The Commission has issued the enclosed Amendment No. 38 to Provisional Operating License No. DPR-16 for the Oyster Creek Nuclear Generating Station. The amendment consists of changes to the Appendix A Technical Specifications in response to your request dated May 23, 1979 (Addendum 1 to Change Request No. 72 dated May 19, 1979), as supported by your letter dated May 19, 1979, and the enclosed analysis titled "Bounding Loss of Coolant Inventory Transient for the Oyster Creek Plant."

OYSTER CREEK NUCLEAR GENERATING STATION, UNIT NO. 1

AMENDMENT TO PROVISIONAL OPERATING LICENSE

Amendment No. 39
License No. DPR-16

FIGURE 3.10-1

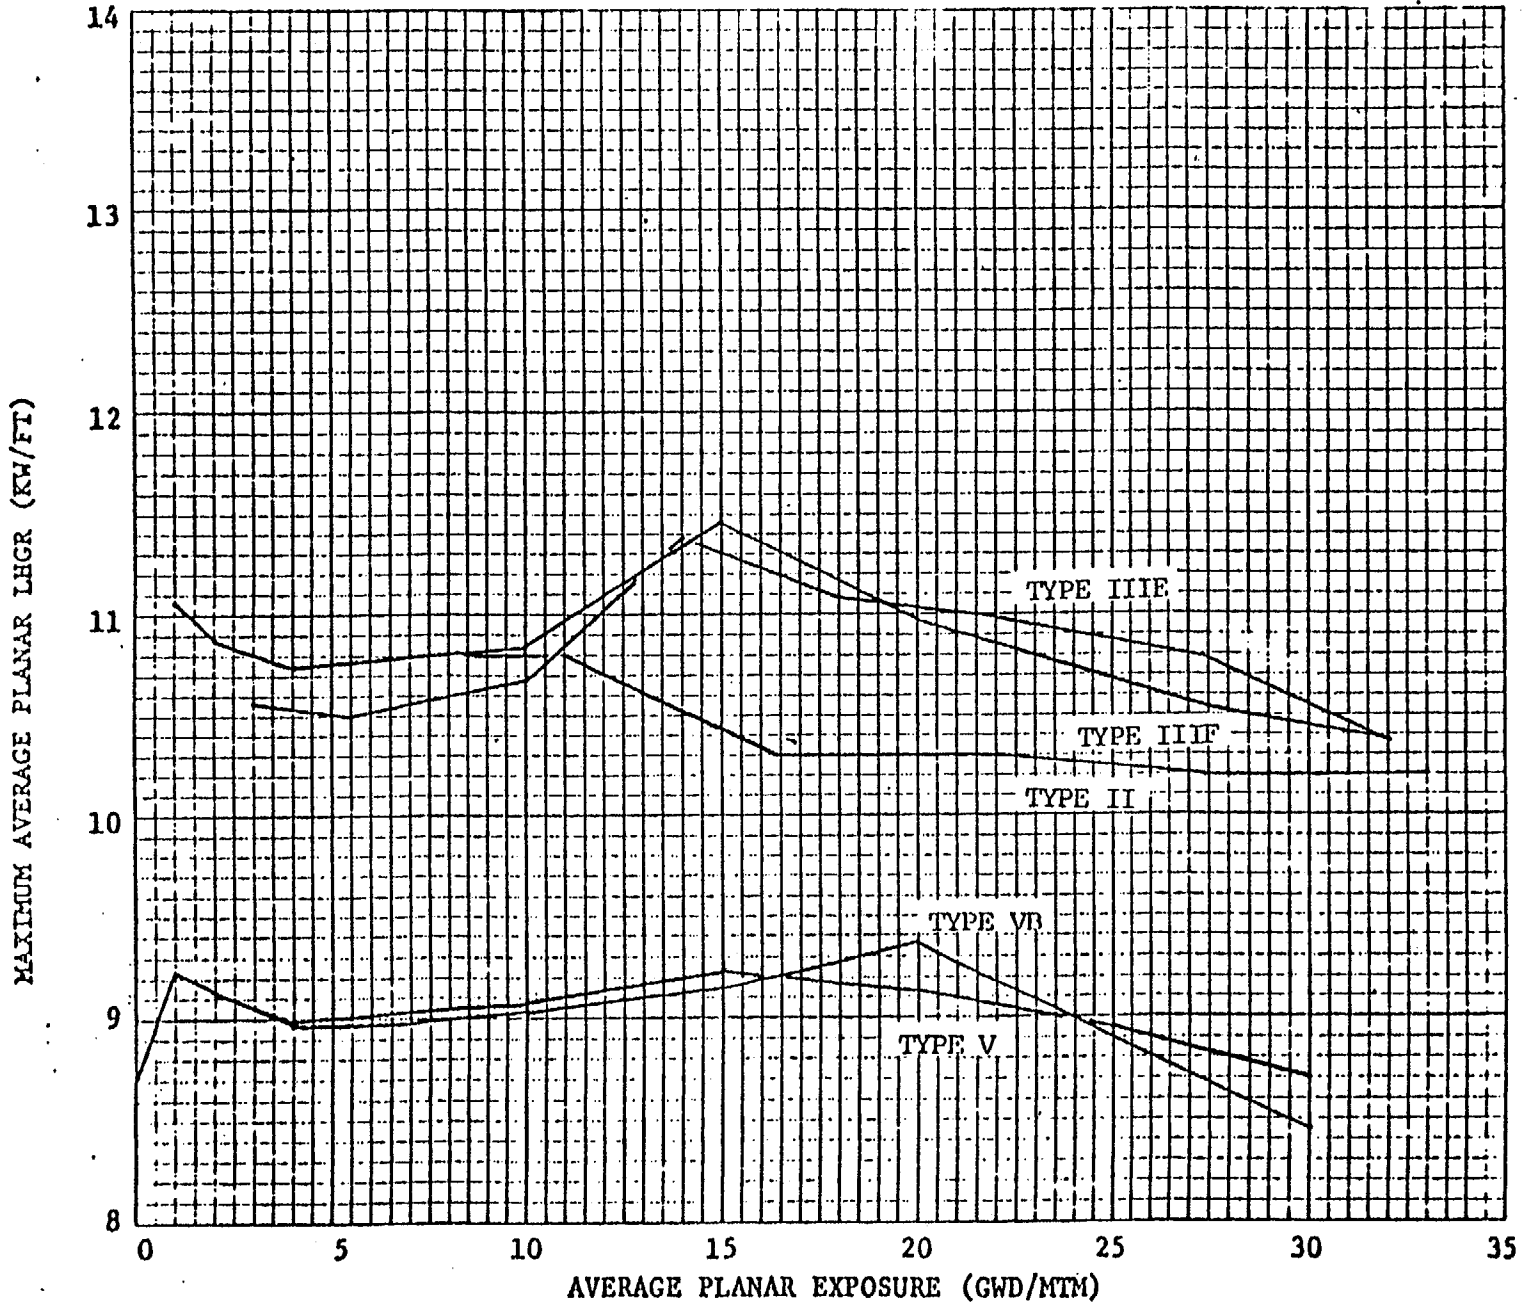
The amendment: 1) adds a limiting safety system setting for the automatic initiation of the Isolation Condenser on a reactor low-low water level signal (Section 2.3), 2) revises Table 3.1.1 to reflect the change in 1) above, 3) adds the Assembly Average Power Void Relationship for all fuel types in the reactor (Section 3.10.c), 4) removes Figure 3.10-2 and the reference to Figure 3.10-2 from Section 3.10.A, and 5) removes the word interim from Figure 3.10-9, which was inadvertently included in the title of this Figure during the issuance of License Amendment No. 35, dated May 30, 1979.

Based on the above conclusions, the staff issued License Amendment No. 35 (Reference 3). However, the Technical Specification changes incorporated with License Amendment No. 35 were incomplete. Although the proper limits had been incorporated some of the text material still referred to the limits established by License Amendment No. 33, dated November 11, 1978. To correct these inconsistencies, the following changes should be made. The licensee agrees with these changes: 1) reinstating the Assembly Averaged Power Void Relationship for all fuel types on page 3.10-2 which was removed by Amendment No. 33, 2) delete the word Interim from the title of Figure 3.10-1, which was on the copy submitted by the licensee and inadvertently not removed, 3) remove Figure 3.10-2 and delete the reference to Figure 3.10-2 from page 3.10-1 since the axial multiplier was derived for the less restrictive MAPLHGR limits approved by License Amendment No. 33.

These three changes correct the inconsistencies between the use of the limits approved by License Amendment No. 35 and License Amendment No. 33. Since the changes are administrative and establish the more restrictive limits approved by License Amendment No. 16 and 35 they are acceptable.
